CONTRACT ADDENDUM NO. 1

CITY OF PORT ORCHARD

Bethel Ave, Bethel Rd, Lincoln Ave SE, Mitchell Rd SE

**Project No. PW 2024-003
TIB Project No. 8-2-153(003)-1**

BETHEL AVE, BETHEL RD, LINCOLN AVE SE, MITCHELL RD SE		JOB NUMBER 20155
DEMOLITION PLAN		SHEET 04 OF 89 SHEETS

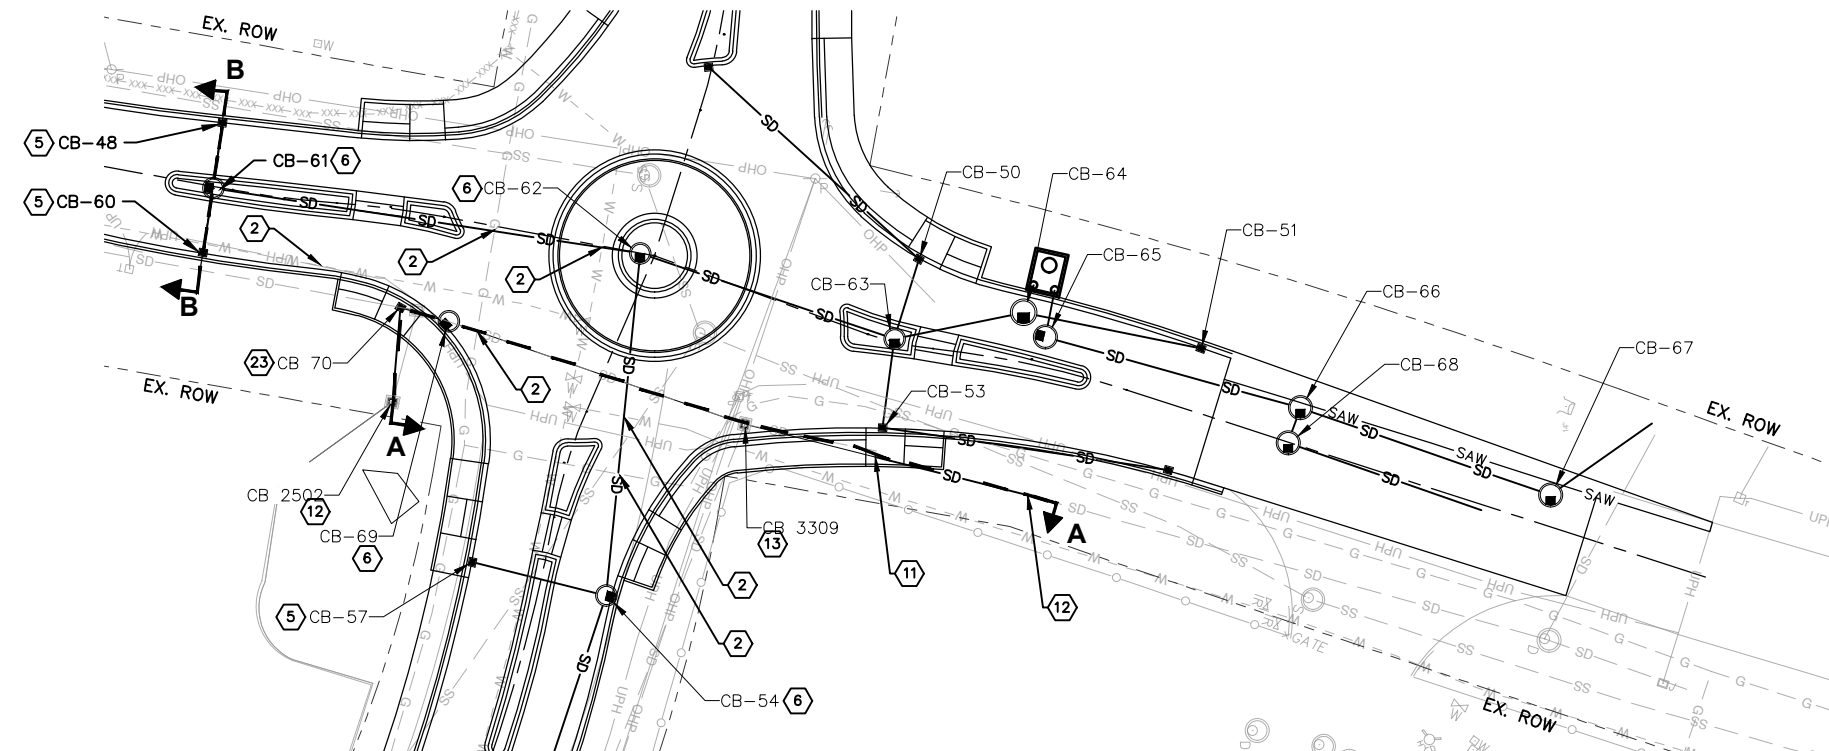
- Sheet 04 Demolition Plans is deleted and replaced with Sheet 04 attached to this addendum. Revised to clarify location for fence removal and replace in-kind.
- Sheet 43 Storm Water Plan & Profile is deleted and replaced with Sheet 43 attached to this addendum. Revised to clarify new versus existing pipe and structures.
- Sheets 81, 82 and 83 Illumination plans are deleted and replaced with Sheets 81, 82 and 83 attached to this addendum. Construction Note 1 has been revised.

3. Refer to sheet 4 of 89. Does the removed fence need to be put back?
Response: Fencing that conflicts with existing Right-of-way on the northeast and southwest corners of the intersection shall be removed and replaced in-kind. Please refer to Section 8-02 "Roadside Restoration" in Special Provisions.

| 6 REMOVE EX. DRAINAGE STRUCTURE | 20 REMOVE AND REPLACE FENCE IN-KIND. |
